Access Compliance Report

Public Rights-of-Way

(Curb Ramps)

Intersection ID: 5967	Main Street: N_TRYON_ST	Cross Street: MCCULLOUGH_DR	Location: W
ADA ID: 944F1DB23B91	Ramp Type: Perp	Initial Pass/Fail: Fail	Overall Compliance: No
Severity Score: 8.75			
Codes/Mitigation Info/Possible Solution		Field Measurements/Component Compliance

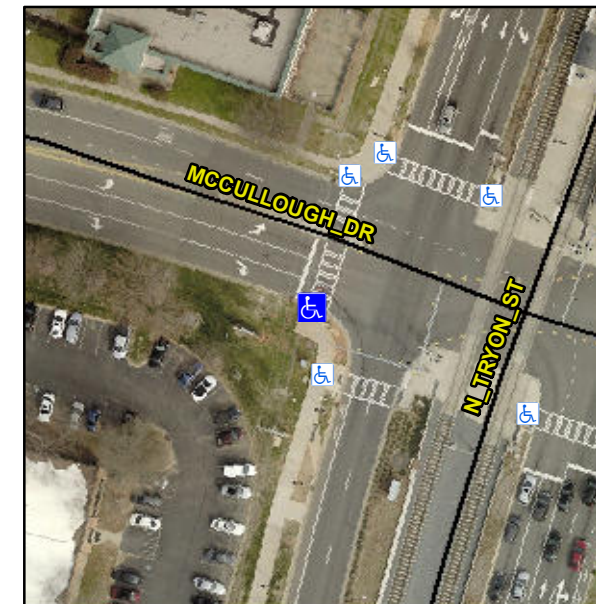
Compliance	Description	Data	Compliance	Description	Data
N/A	Ramp Length (in)	55.0	Yes	Ramp Slope (%)	7.6
No	Ramp Width (in)	46.0	Yes	Ramp XSlope (%)	1.1
N/A	Flare Type LT	N/A	N/A	Flare Type RT	N/A
N/A	Flare Slope LT (%)	N/A	N/A	Flare Slope RT (%)	N/A
N/A	Flare Traversable LT?	N/A	N/A	Flare Traversable RT?	N/A
N/A	Landing Length (in)	N/A	N/A	DWS Provided?	N/A
N/A	Landing Width (in)	N/A	N/A	DWS Contrast?	N/A
N/A	Landing Slope (%)	N/A	N/A	DWS Length (in)	N/A
N/A	Landing X Slope (%)	N/A	N/A	DWS Full Width?	N/A
N/A	Landing Curb? (Y/N)	N/A	N/A	DWS Offset (in)	N/A
N/A	Shared Landing?	N/A			
N/A	Gutter Ponding?	N/A	N/A	Gutter Slope (%)	N/A
N/A	Gutter Lip Ht (in)	1.0	N/A	Gutter X Slope (%)	N/A
N/A	Painted X Walk1?	Yes	N/A	Painted X Walk2?	N/A
	X Walk 1 Direction	To NE		X Walk 2 Direction	N/A
N/A	X Walk 1 Width (in)	119.5	N/A	X Walk 2 Width (in)	N/A
	X Walk 1 Slope (%)	0.7		X Walk 2 Slope (%)	N/A
	X Walk 1 X Slope (%)	1.3		X Walk 2 X Slope (%)	N/A

Remove & Replace Entire Ramp.
